Shipra Fashion Ltd.

20 March 2023

Observations

Bolt missing and connection gap

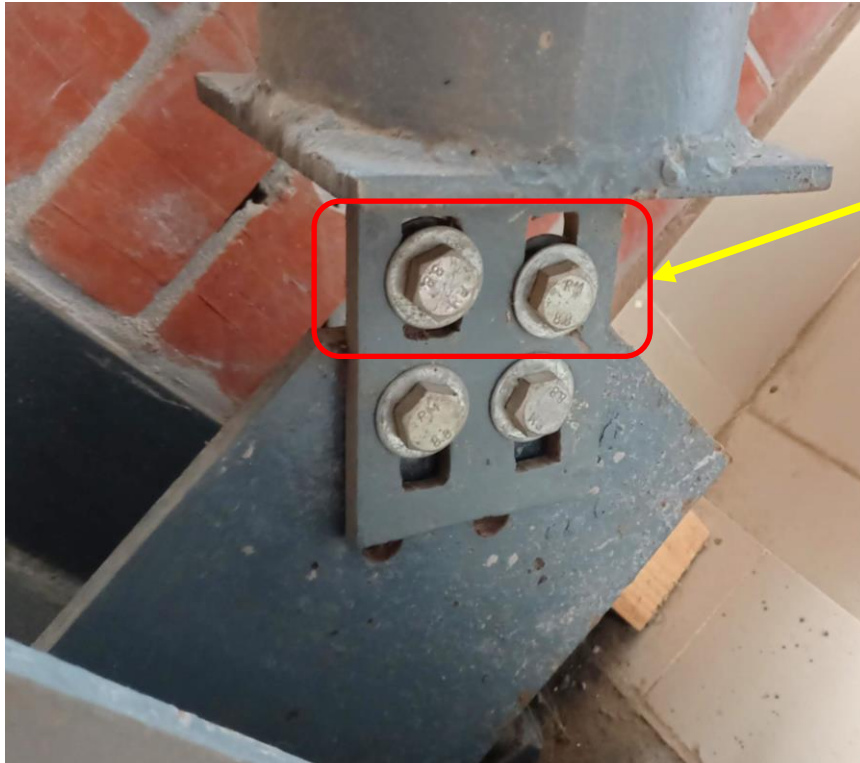
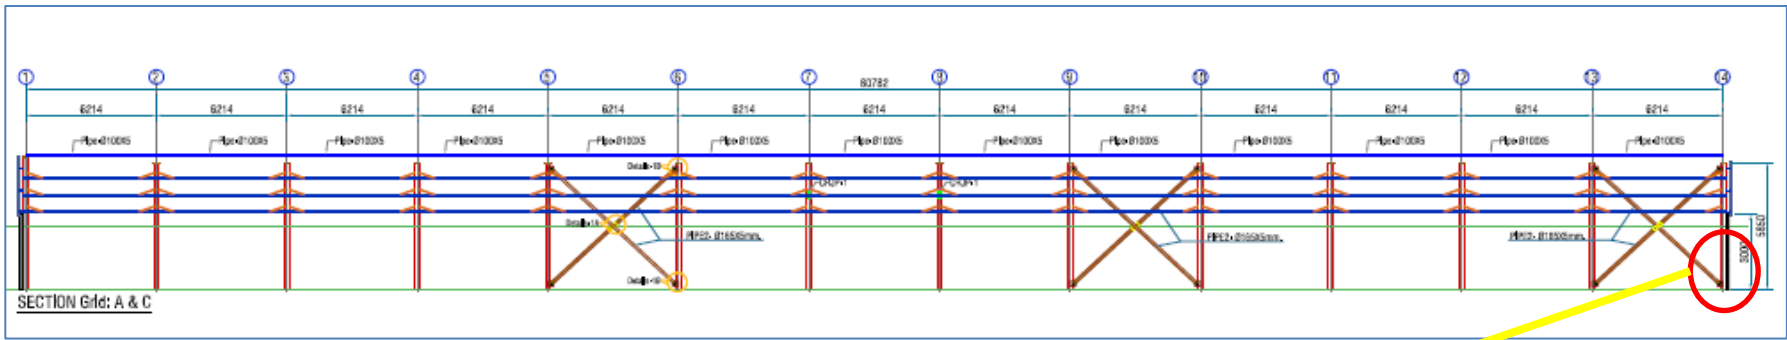
Bolt missing and significant gaps observed in rafter-column joint at several locations. Building engineer is required to install the missing bolts and carry out suitable remedial works.

Bolt missing

Gap observed in connections

Observation: Finishing & Warehouse Shed

Bolt placed out gusset plate

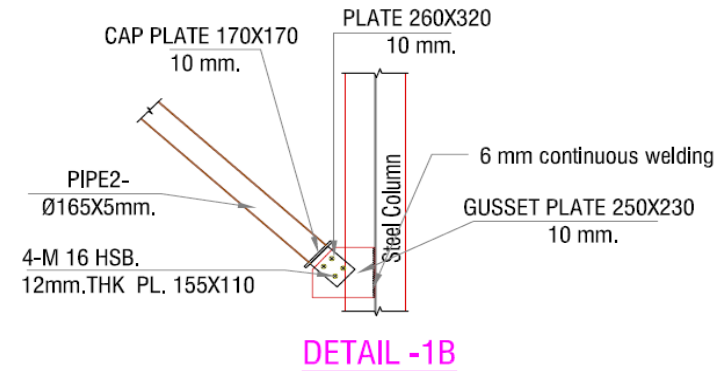
2 out bolts are not connected with gusset plate and Long slotted holes in the connection

2 out of 4 bolts are not connected with gusset plate. Rest of 2 bolts are connected with large slotted holes which is placed along the line of action of forces. The connection may not functional due to lack of active bolts and loose connections. However, the building engineer is required check the connection type, code requirements for long slotted holes & connection design method and suggest suitable repair action accordingly.
